Docket Item #3
BAR CASE # 2016-00436

BAR Meeting
January 18, 2017

ISSUE: Certificate of Appropriateness for Alterations

LOCATION: 682 North Saint Asaph Street

Figure 1: proposed placement of awning highlighted in green; the new awning will mimic the canopy configuration of the retail space to the south (left side of image). Image courtesy of Google Maps, October 2016.

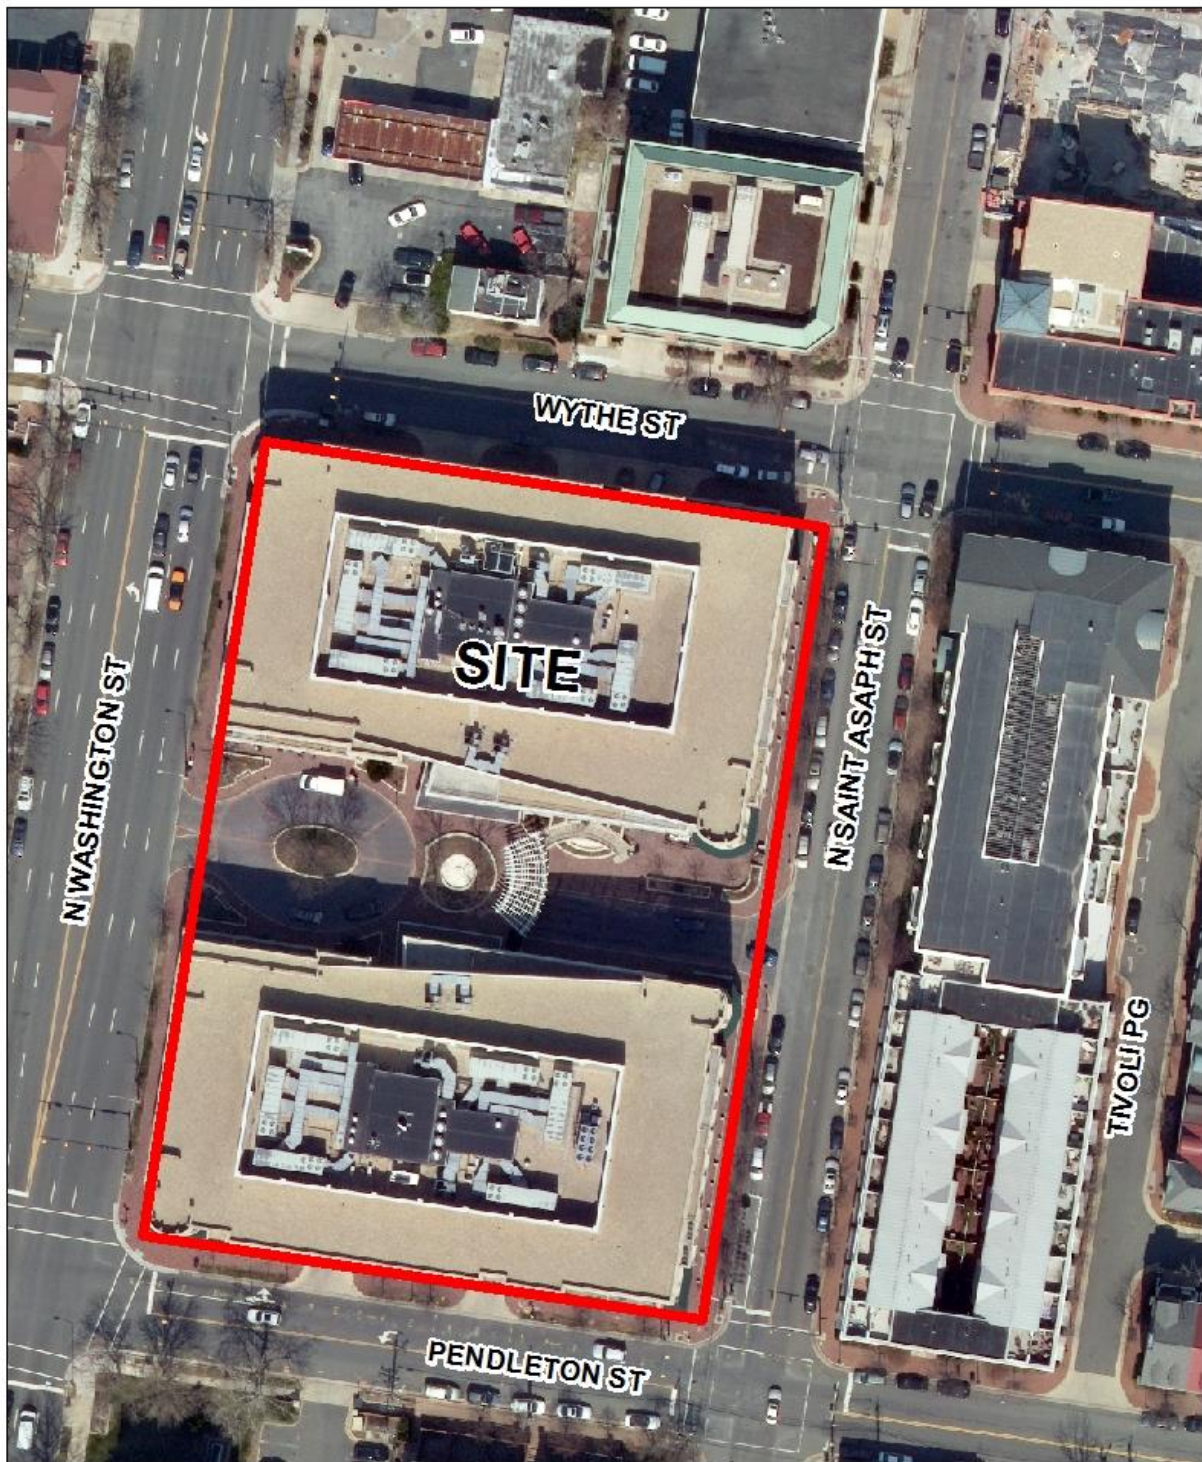
The shed-style awning requires a metal, three-bay frame which will be directly affixed to the south exterior wall above two side entrance doors flanking a central storefront window. The awning's placement will not obscure the extant signage. The Sunbrella® acrylic fabric will be a hunter green color that matches that on the existing awning; it will be devoid of writing. The awning will measure 219 inches wide by 42 inches long (a 30-inch rise with a 12-inch drop, or valence); it will extend 48 inches from the wall surface. The new awning will meet the existing one at the building's rounded corner, creating a continuous span similar to that found on the opposite business addressed 612 North Saint Asaph Street (occupied by *Trader Joe's*). (Figure 1)

Staff believes the installation of an awning over the side entrance at *Sunday in Saigon* will not obscure or damage any historic fabric, as the building is an early 21st-century construction. Furthermore, its addition will create a symmetrical balance with the awning configuration at the retail space to the south, currently occupied by *Trader Joe's*. (Figure 1) The lack of text on the
